**DRURY SOUTH - PRELIMINARY RECOMMENDATIONS**

**MARSHALL DAY ACOUSTICS LTD**

**Figure 1: Precinct plan**

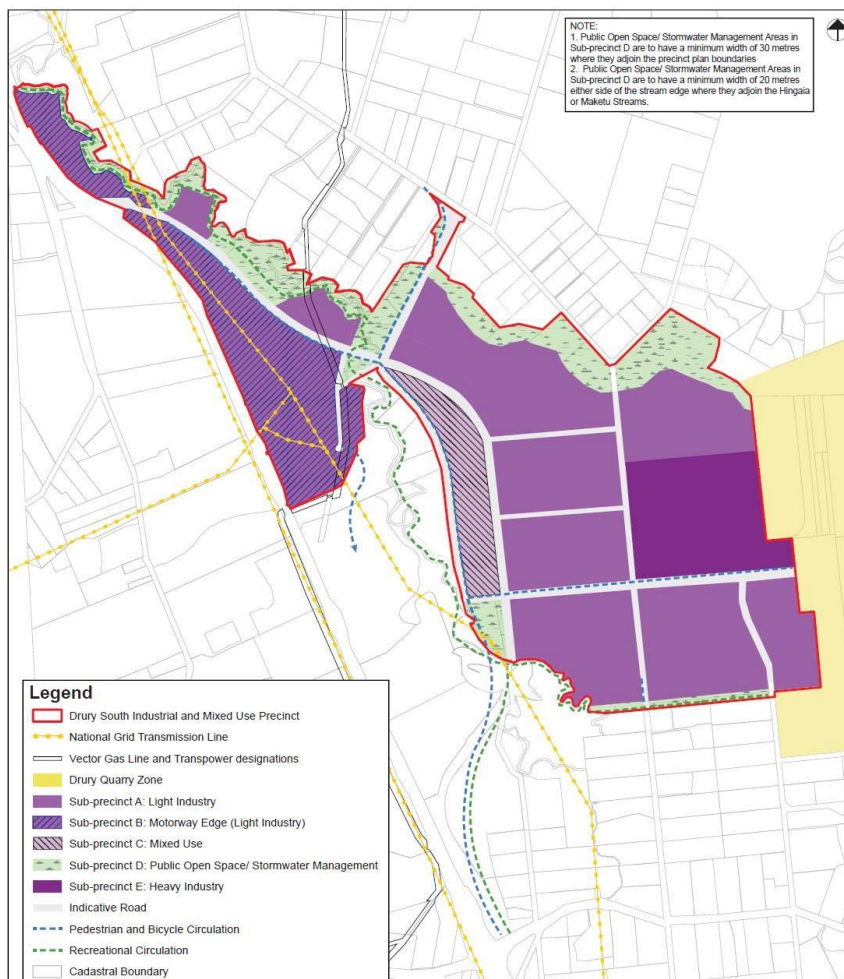
The Drury South Plan Change has recently been updated with the following changes:

- Rezoning of Sub-Precinct C from Light Industry to Mixed Use
- Rezoning of some Heavy Industry zones to Light Industry

As such, an acoustic assessment is required to identify potential issues. This letter provides a high-level analysis of the updated Plan Change and makes some recommendations.

Figure 2: Indicative noise level based on existing typical road section

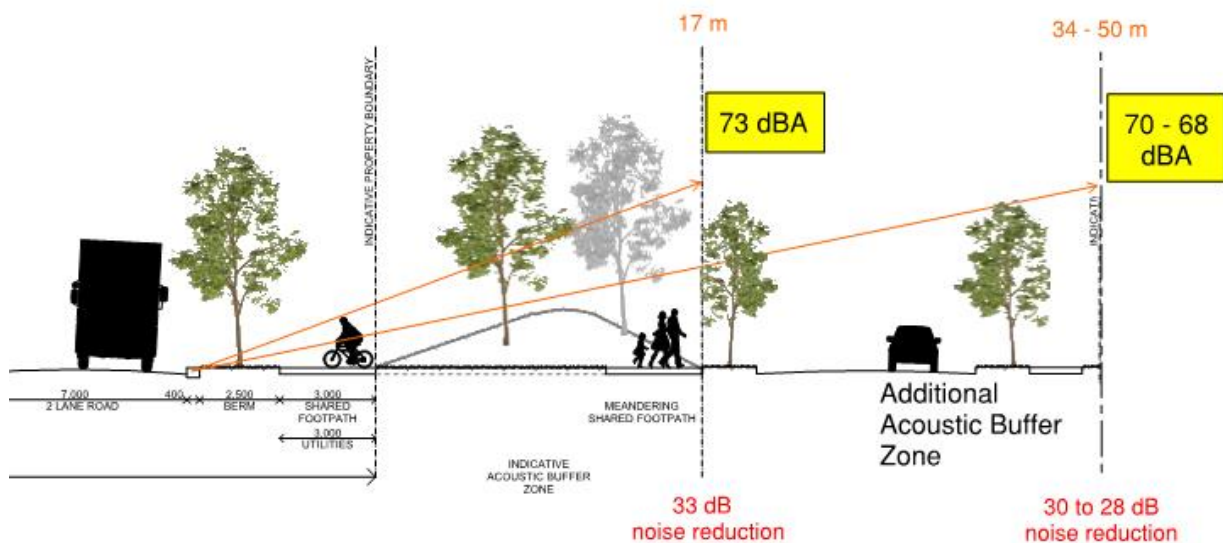
- The noise condition for residential activity near the Spine Road is for a noise limit of 40 dB  $L_{Aeq(24hr)}$  in a habitable area based on a Spine Road traffic noise level of 75 dB  $L_{Aeq(24hr)}$  at 10m. This would require a facade noise reduction of 33 decibels for any dwelling located immediately adjacent to the acoustic buffer zone and 28 decibels for those dwellings located approximately 50 m from the curb of the Spine Road (Figure 2).

- Furthermore, the Unitary Plan sets façade noise performance standards for habitable rooms to provide additional control from commercial uses. These are:
  - o Bedroom Noise reduction of 20 dB @ 63 and 125 Hz
  - o Living Noise reduction of 25 dBA
- It is considered that the two rules would provide an equivalent result at approximately 50 m from the curb of the Spine Road.
